Manningham Council
Delegation Report

Application No.	PLN18/0598
Application Received	7 September 2018
Amendment Received	18 July 2019
60 Day Statutory Time Frame	7 October 2019
Officer	Julie Mikkelsen / Christine Daly
Delegate	Jeff Gower

Address	21 Glendale Avenue TEMPLESTOWE
Proposal	Construction of six, two-storey dwellings and associated basement garage
Ward	HEIDE

NOTICE OF DECISION TO REFUSE TO GRANT A PERMIT PLN18/0598

COLOUR AND MATERIAL SCHEDULE

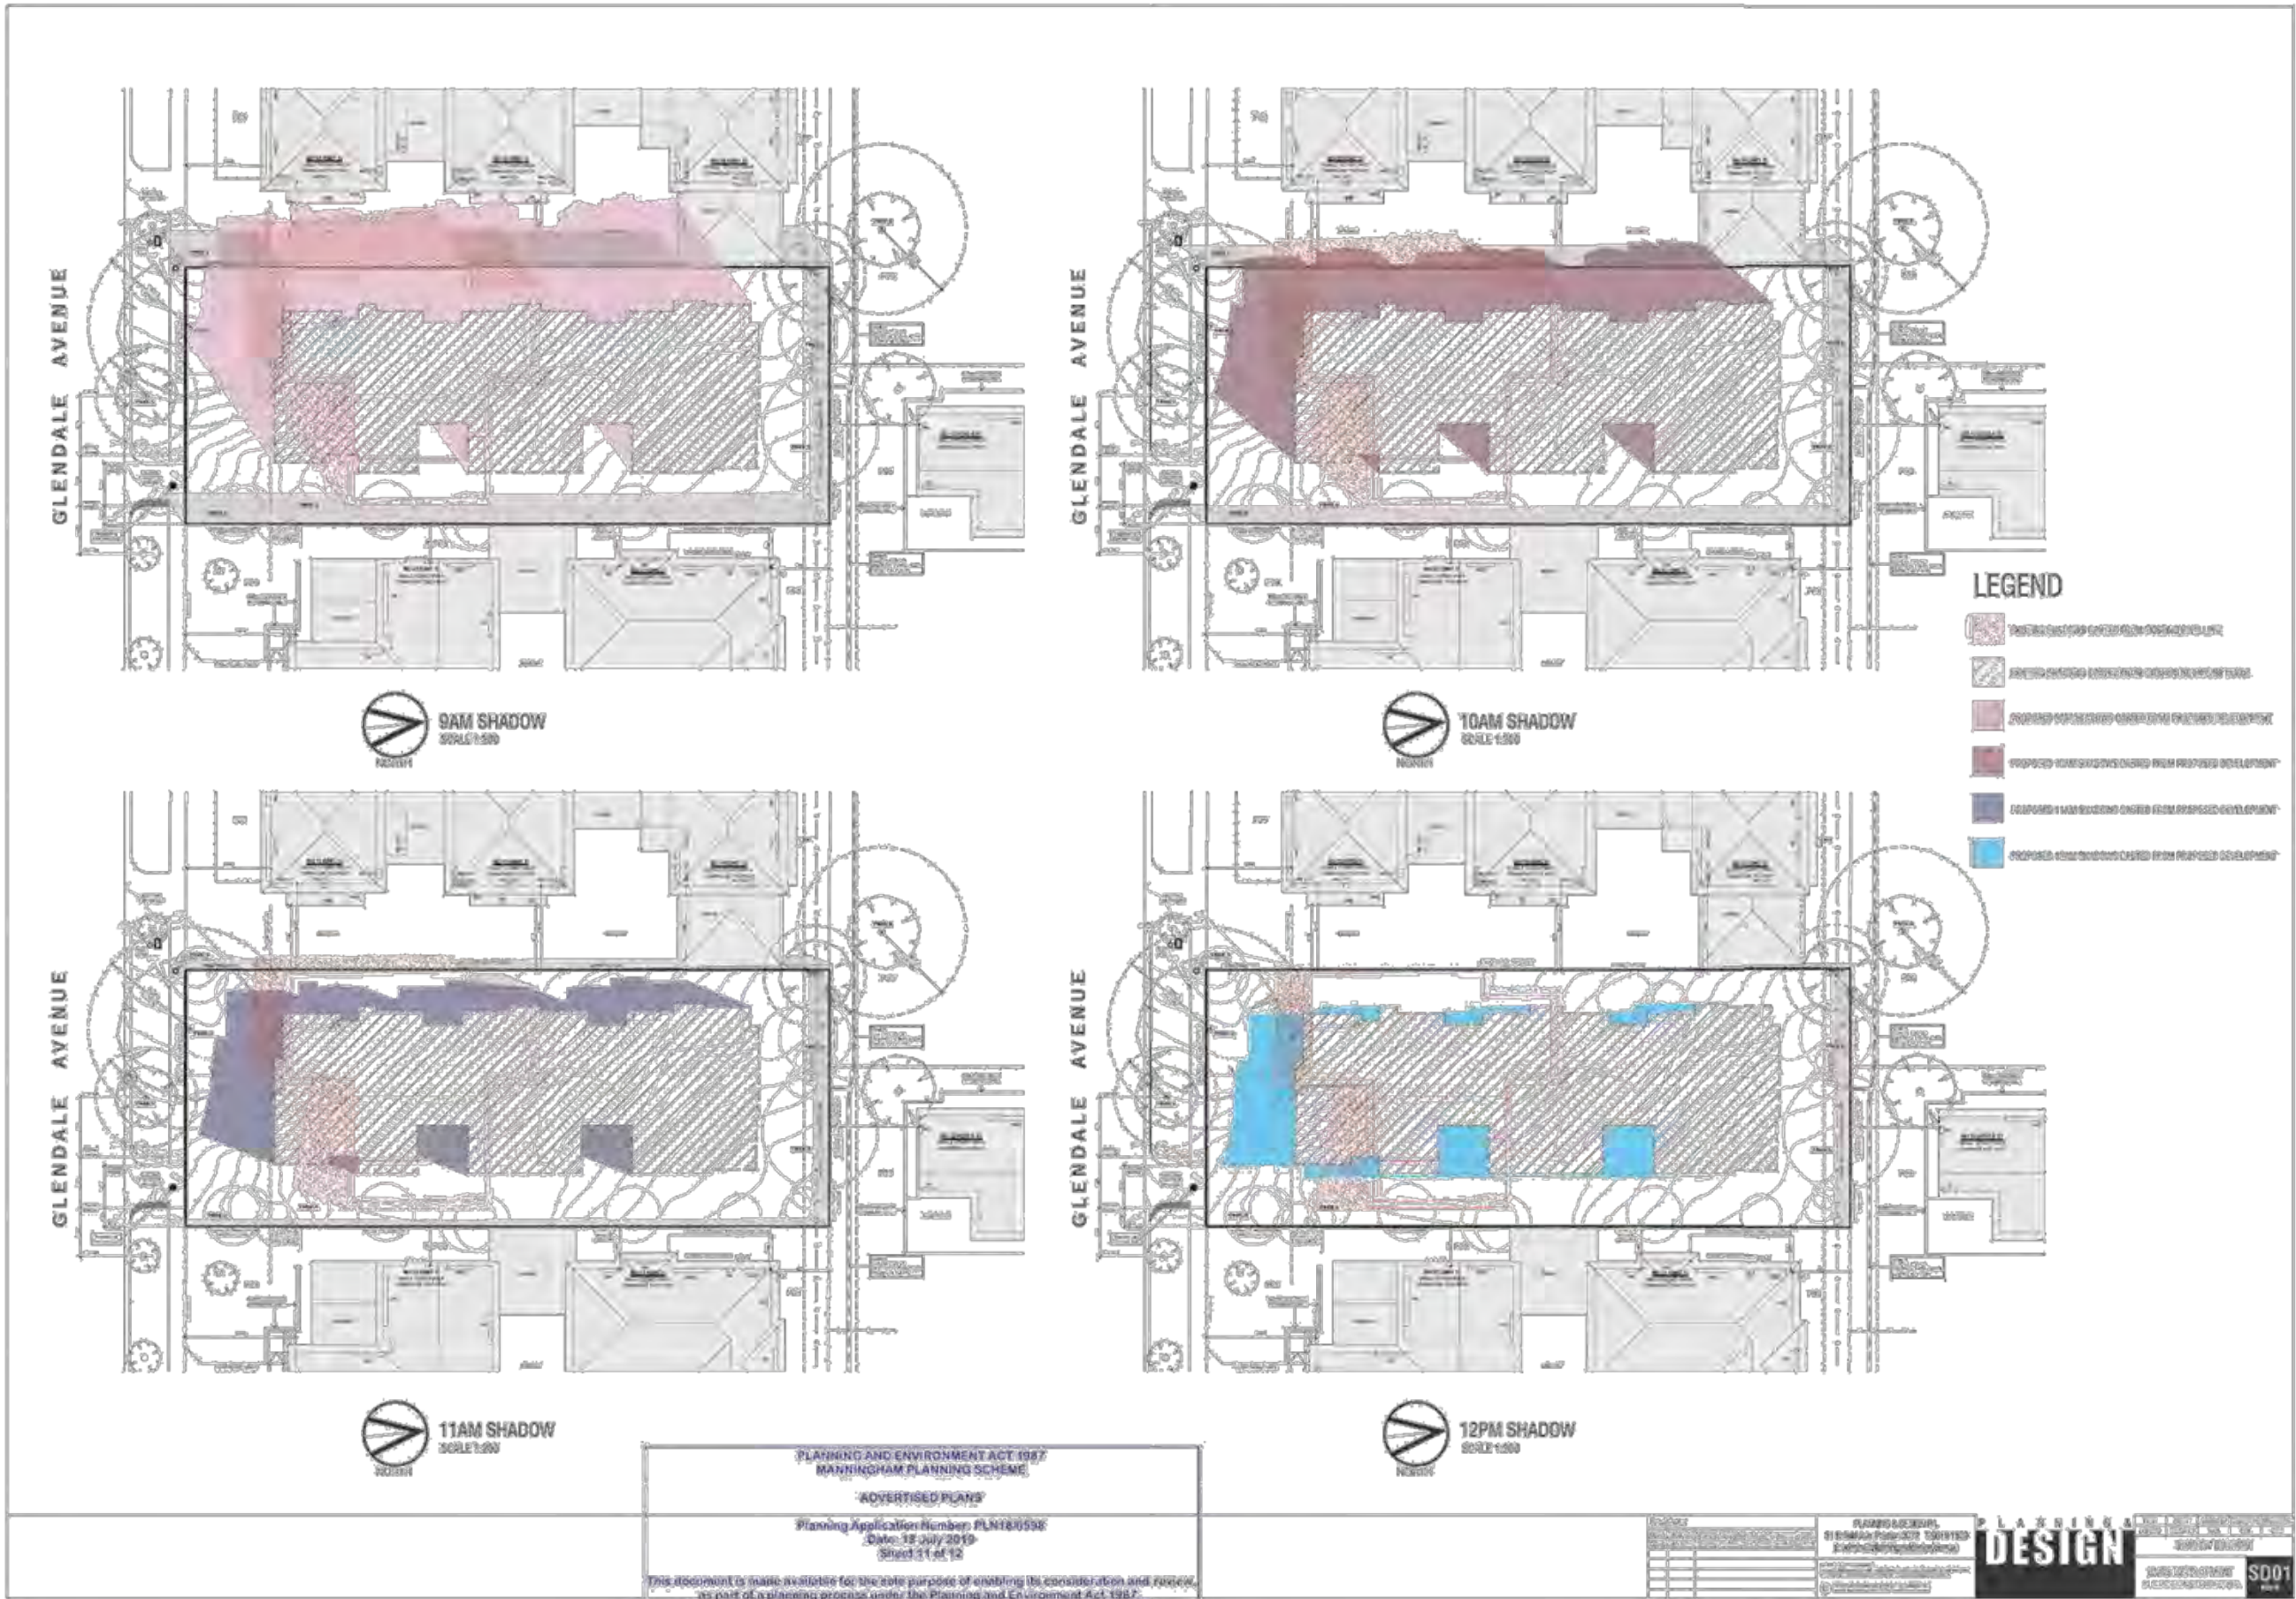
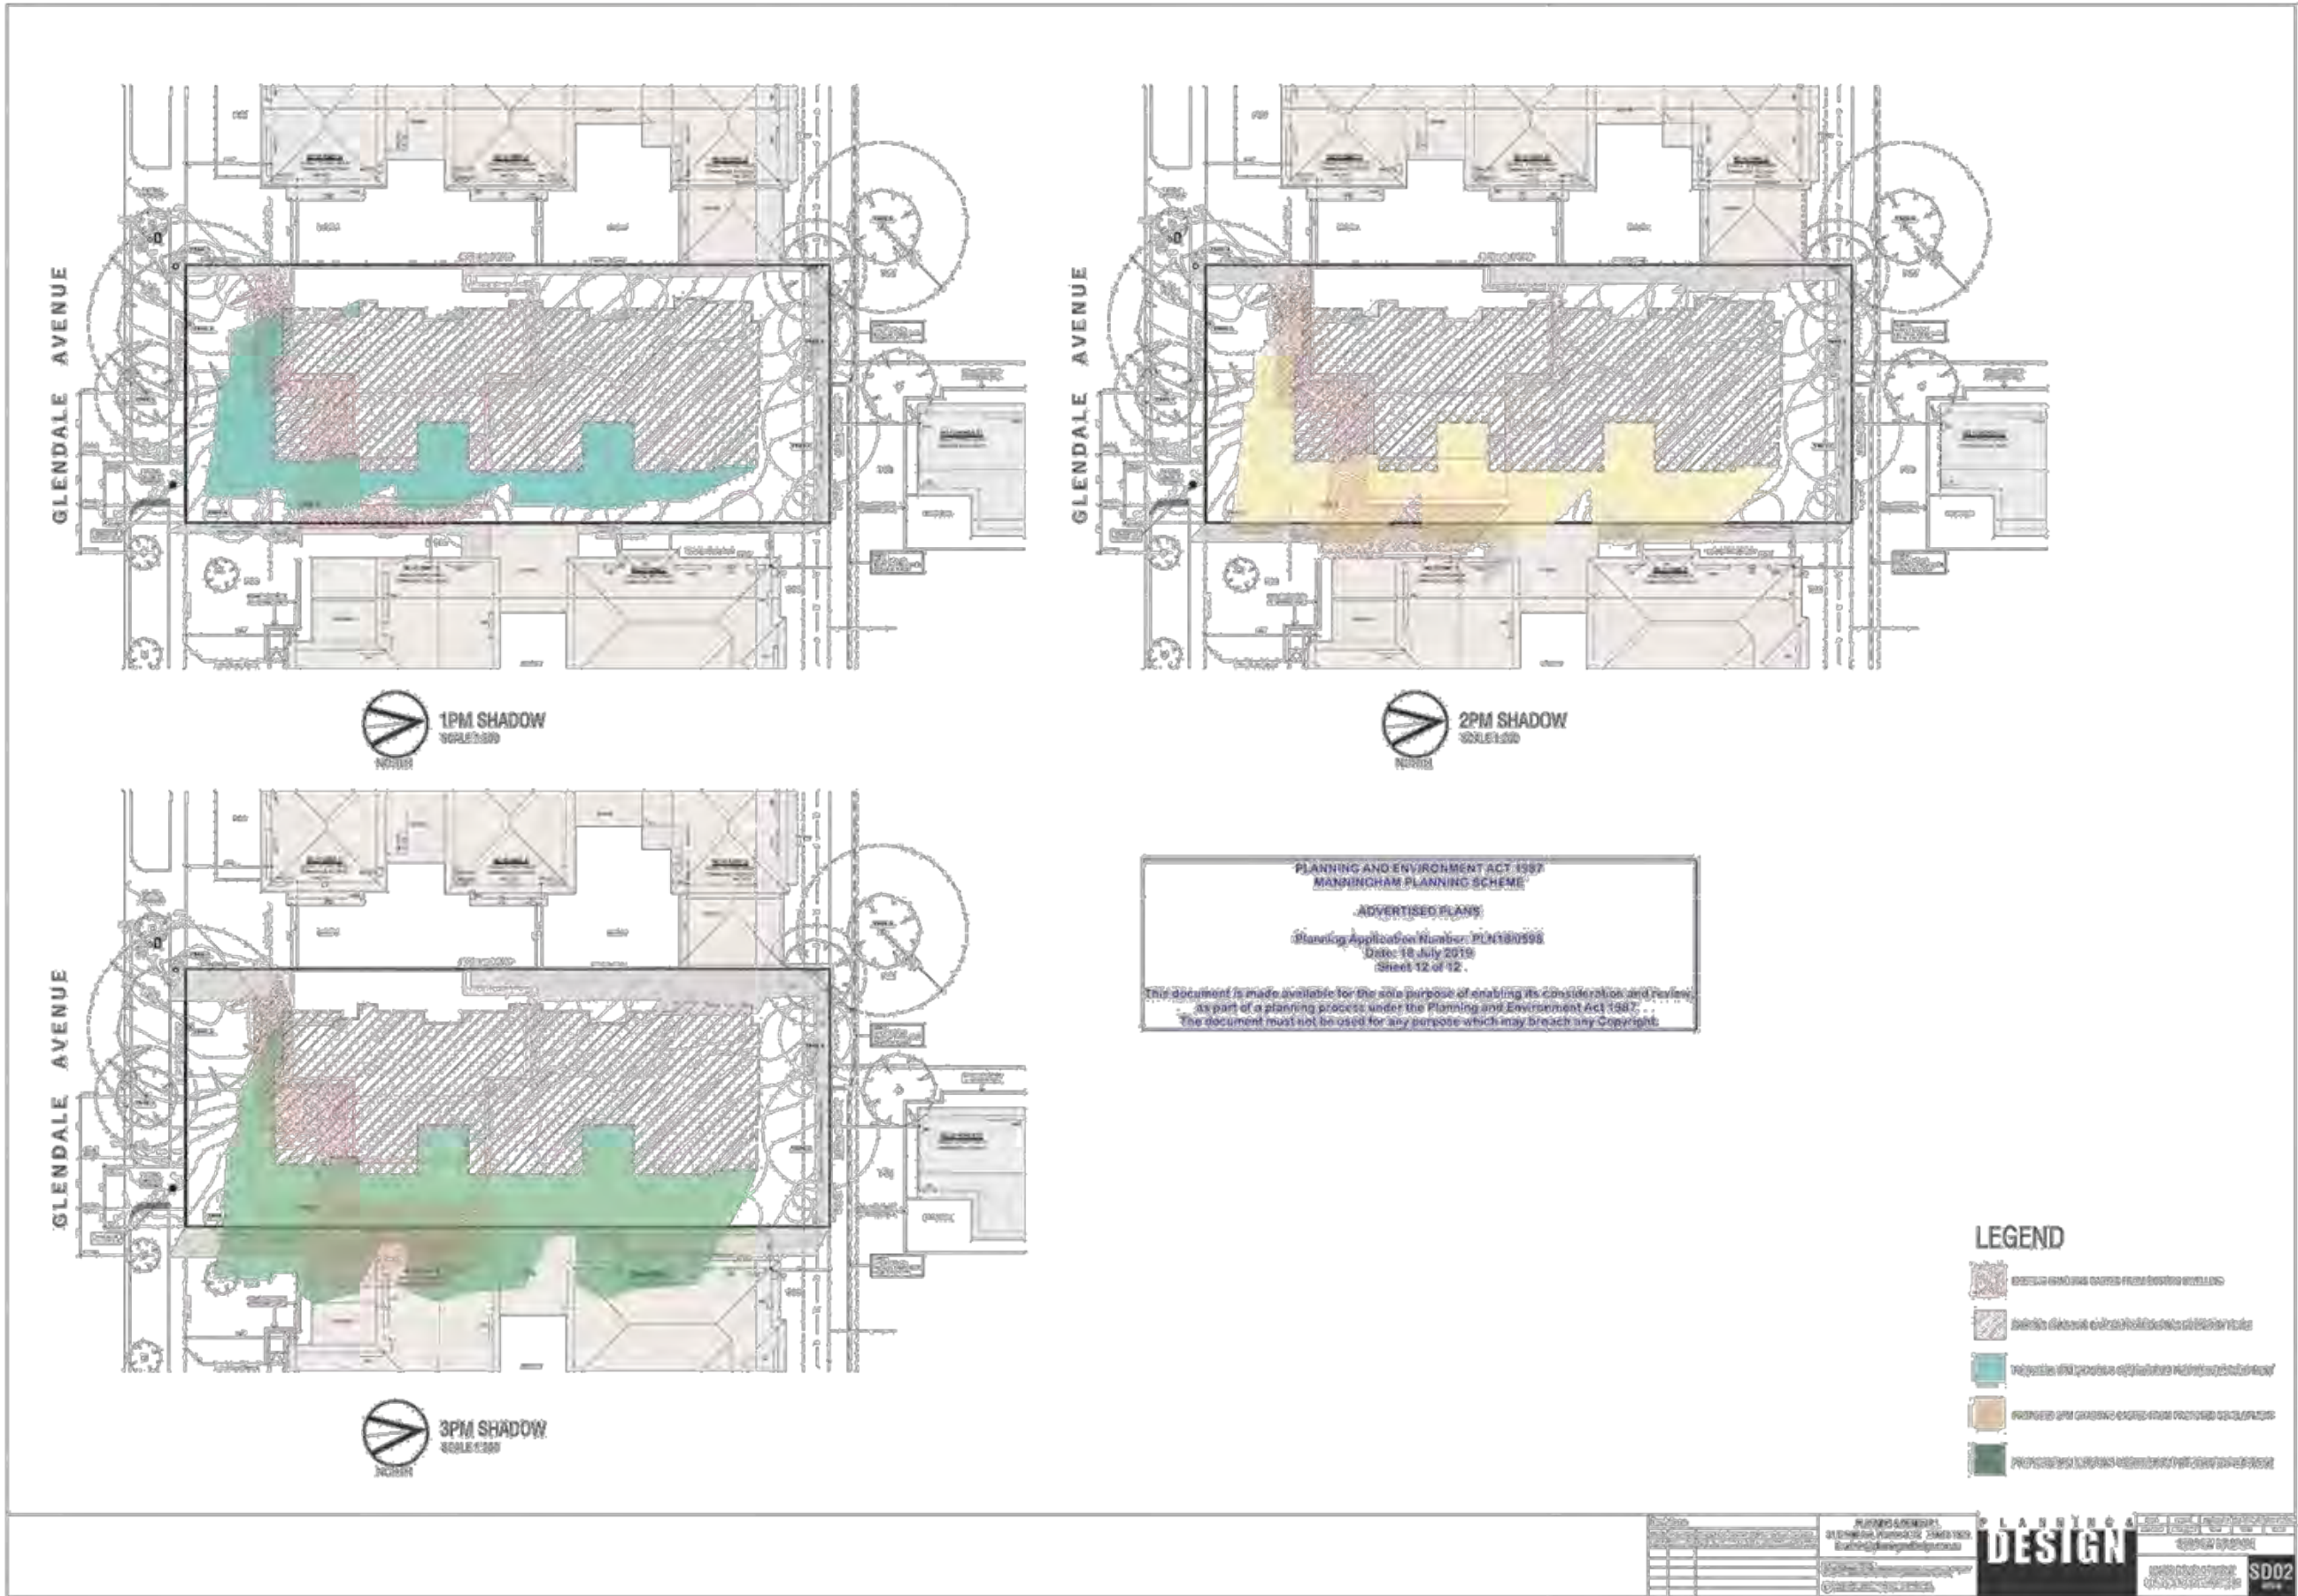
Whilst there is variation in the materials and textures of the building, there are other architectural features [particularly the first floor window shrouds] that overwhelm the built form.
